Re: ACTION RE: PETITION FROM MCDONALD'S USA LLC REQUESTING PRELIMINARY APPROVAL OF A PLANNED DEVELOPMENT DISTRICT TO RENOVATE THE EXISTING DRIVE-THRU RESTAURANT ON PARCEL AL-50-8, LOCATED AT 1903 S WEBSTER AVENUE

Date: 24 January 2019

# Preliminary PDD Review – Staff Comments

**Site:** 1903 S. Webster Avenue (Parcel AL-50-8)  
**Petitioner:** Kevin Shay, Landform Professional Services, LLC. (on behalf of McDonald's USA, LLC.)

STATE	WI	CITY	ALLOUEZ
COUNTY	BROWN	STREET ADDRESS	1903 S WEBSTER AVE
DATE REVIEWED	12/26/18	SHEET NAME	SITE PLAN
DATE ISSUED	12/07/18	NATIONAL NUMBER	04481
DATE	12/07/18	STATE NUMBER	048-0174

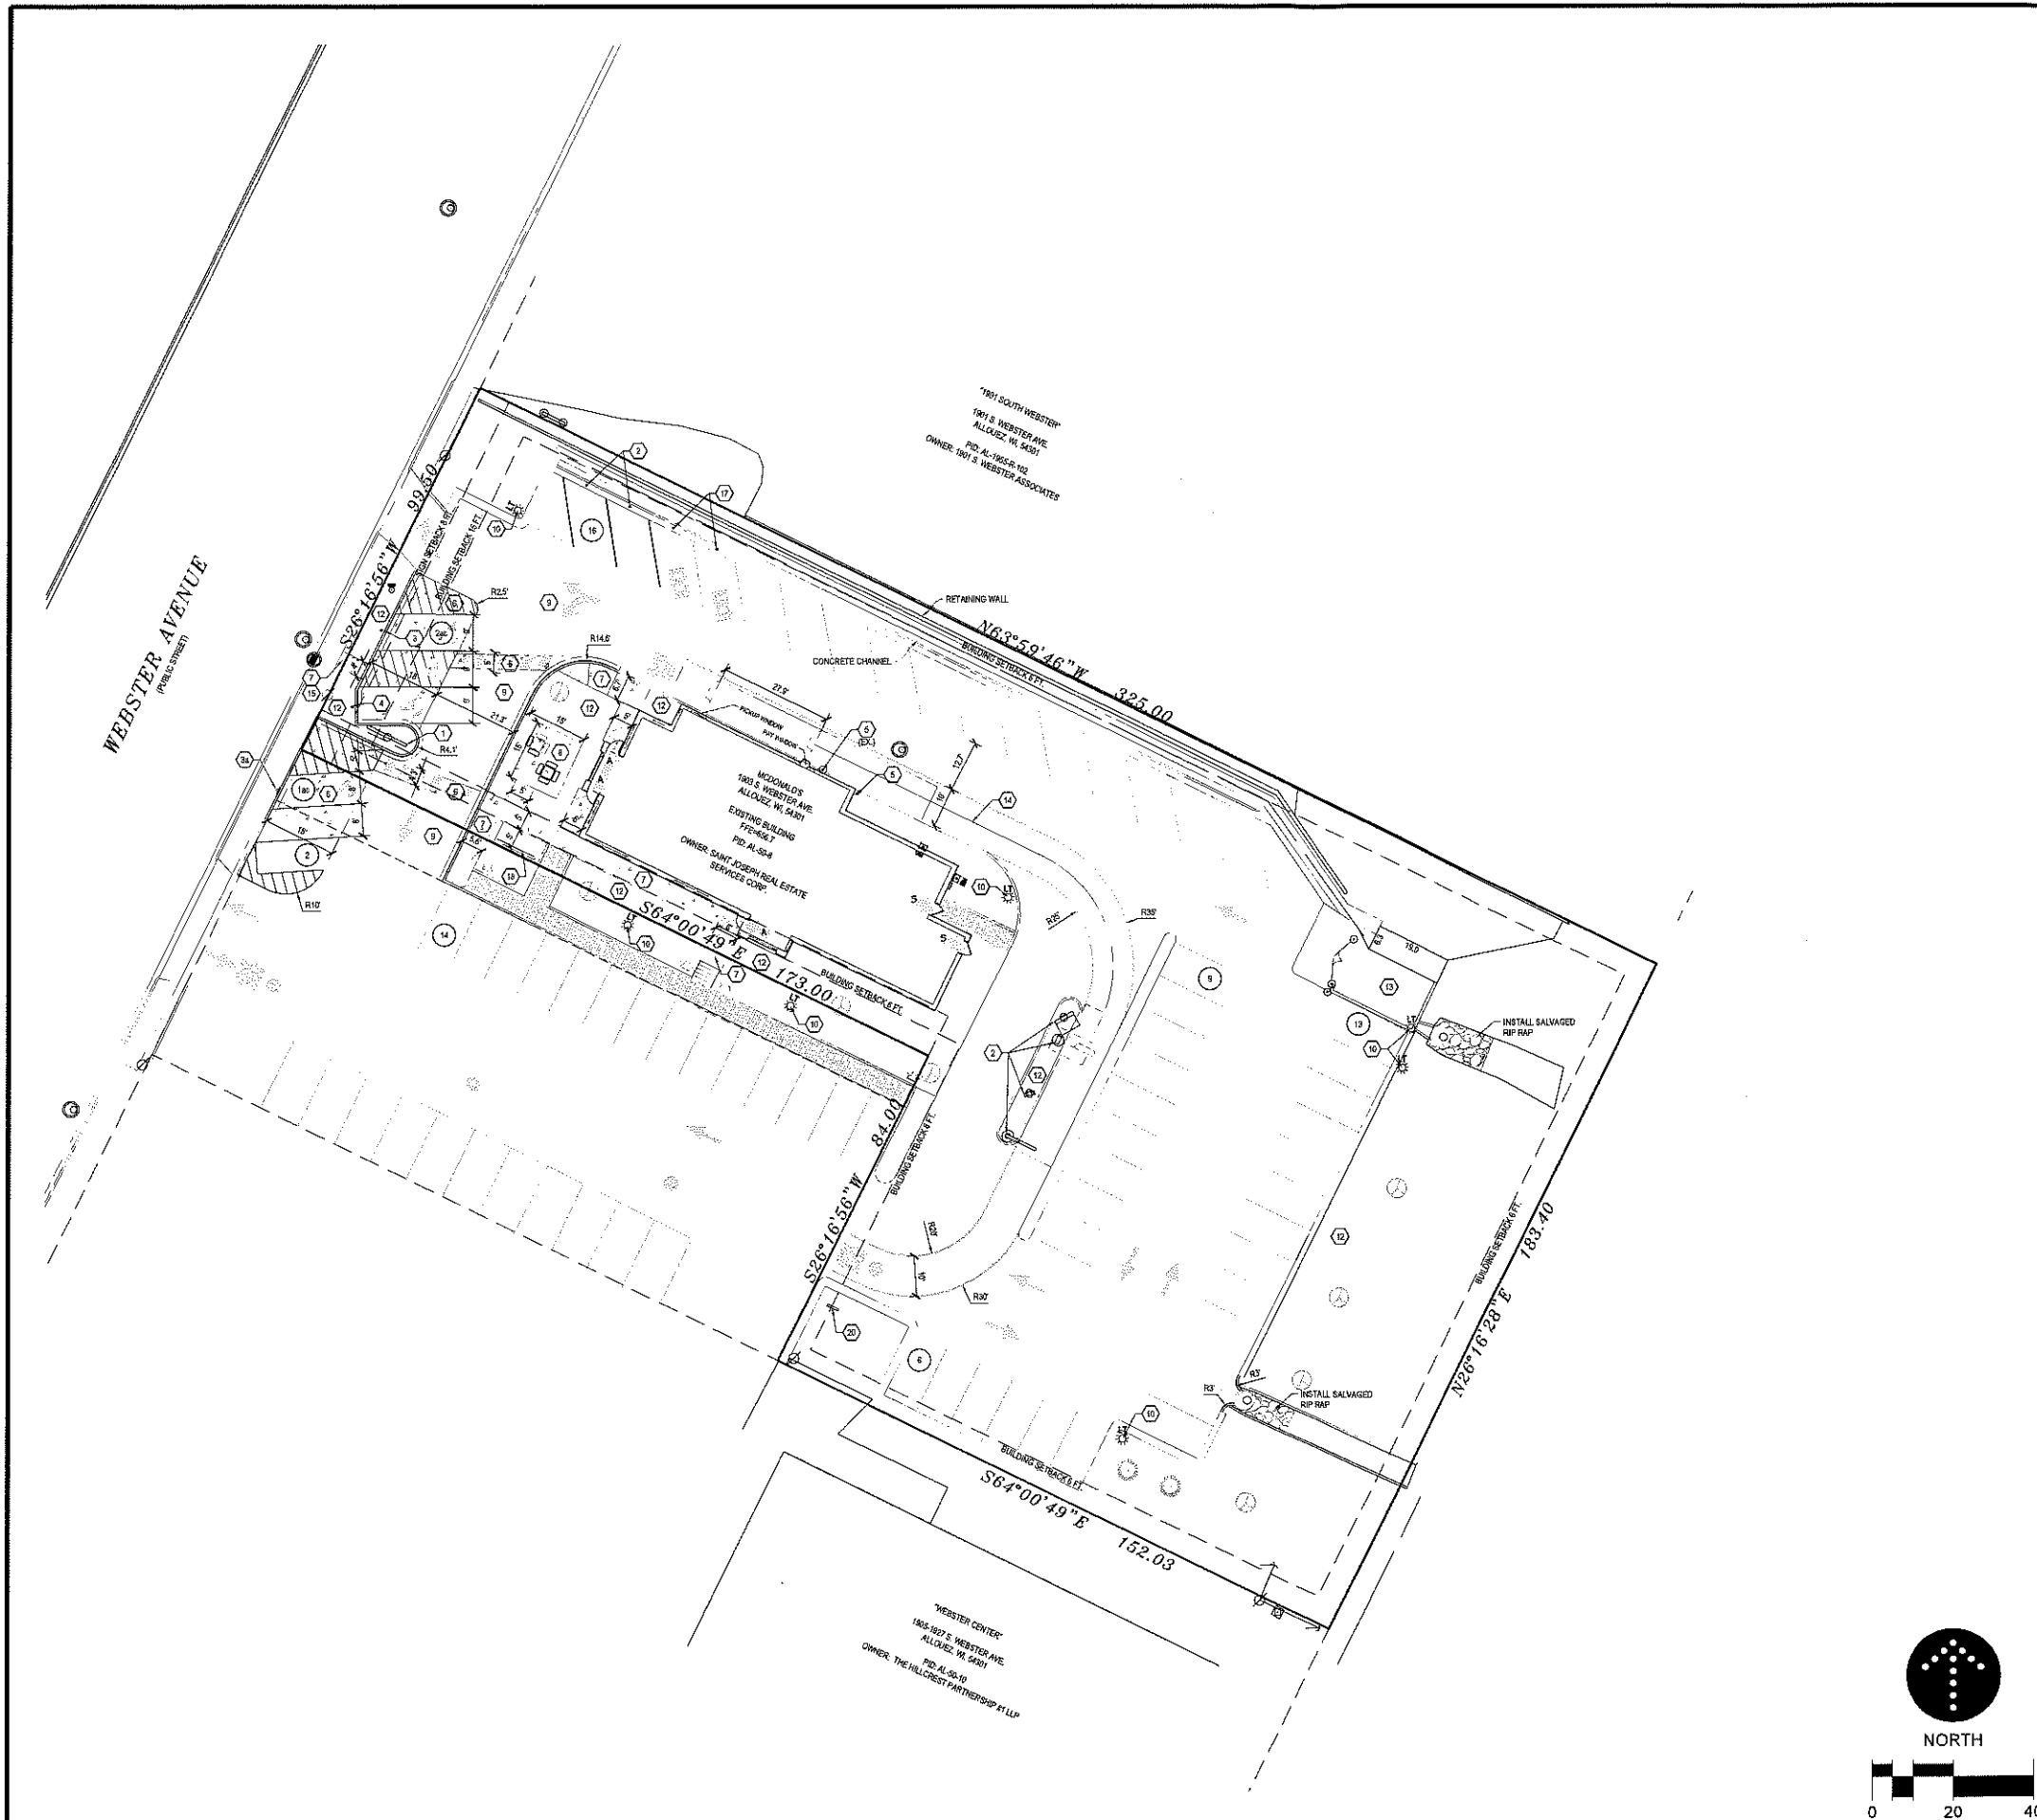
- The property is located on an arterial road (CTH X/Webster Avenue), with commercial uses in the area.
- Items to consider for final approval:
  - A portion of the business parking and one of the ingress/egress is on the neighboring property. Evidence of an established easement for shared parking and ingress/egress between both properties should be provided/established.

- Consideration should be given to a wider sidewalk terrace on Webster Avenue, should the road be reconstructed in the future.
  - A pedestrian connection should be provided from the sidewalk on Webster Avenue to the front entrance of the building.

- Should the parking lot be resurfaced, improvements to the drive aprons should be made to ensure no more than 2% cross-slope in the sidewalk panels.

- Building finishes and features should be of brick, stone, or other approved material.
  - Improvements to the sign should be included in final plan submittal.

- Dumpster enclosure should be of consistent material as the primary building.
  - Designated bicycle parking should be provided.
  - Green space seems to be adequate at this time.
